**Government of India**  
**Ministry of Railways**  
**Research, Designs & Standards Organisation**  
**Manak Nagar, Lucknow - 226 011**

**Modification sheet No. RDSO/WAM4/162**

- 1. Title :** Modification to "L" clamp of commutation pole of TAO 659 Traction Motor.
- 2. Application :** WAM4, WAP1, WCAM1 & WAG5 electric locomotives fitted with TAO - 659 traction motors.

SKEL-4069

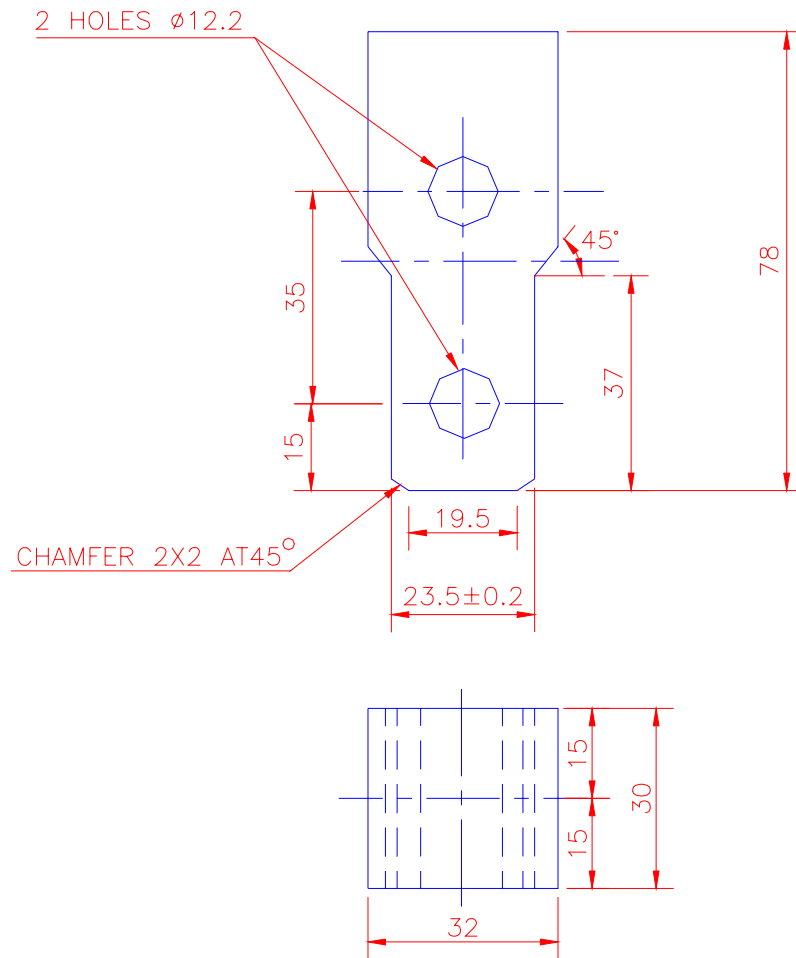
- 4.3 :** The plug weld should be eliminated as being done at present. Butt welding of angle with intermediate support block should be adopted as shown in the drawing attached.

- i) Modified "L" clamp as per RDSO's drawing No. SKEL - 4070.
- ii) Modified intermediate support block as per RDSO's drawing No. SKEL.-4069.

2	L-CLAMP	6	BSS:970 En.58E	—
1	INTERMEDIATE SUPPORT BLOCK	3	STEEL IS:226, ST-425	—
ITEM	DESCRIPTION	No.OFF.	MATL.&SPEC.	REMARKS
REF:	SCALE:-	1:1	APPROVED:-	FOR DG.
INTERMEDIATE SUPPORTING BLOCK ASSY. FOR THE COMM. POLE OF TAO-659 T.M.				
R.D.S.O.ELEC.DTE.			SKEL - 4070

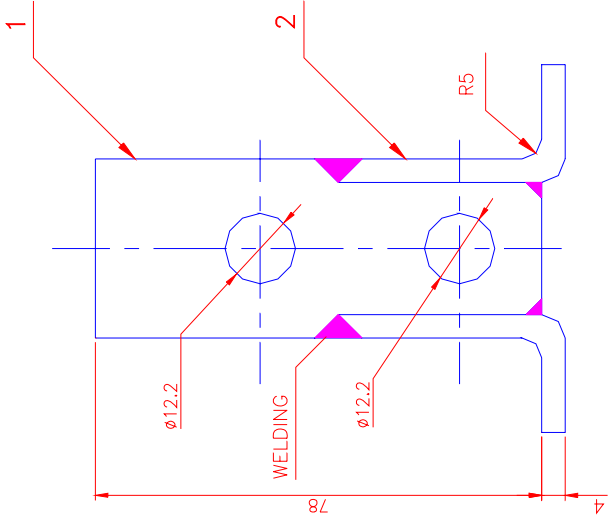
- 3. Object :**
- 3.1 :** Railways have reported No. of cases of interpole coils getting earthed due to breakage/fracture of 'L' clamp stainless steel supporting angle ( Ref. Item No.2 of CLW's drawing No.4 TWD. 092. 092) The stainless steel angles are reported to be breaking at bend portion or through plug weld.

- 4.1 :** Adopt the revised radius at bend portion of 'L' clamp from R4 to R5. The thickness of the angle is also increased to 4 mm
- 4.2 :** The angle should be bent on a special bending tool to ensure that bend radius is not more than R5

- 4.4 :** Welding electrode of size 3.15 mm dia should be used. It is recommended to adopt grade 107, welding electrode of M/s Advani Oerlikon.
- 4.5 :** The welding current shall be limited to 100-130 Amp.

- 4.6 :** Each assembly after welding shall be checked for proof load test to ensure proper quality of welding.
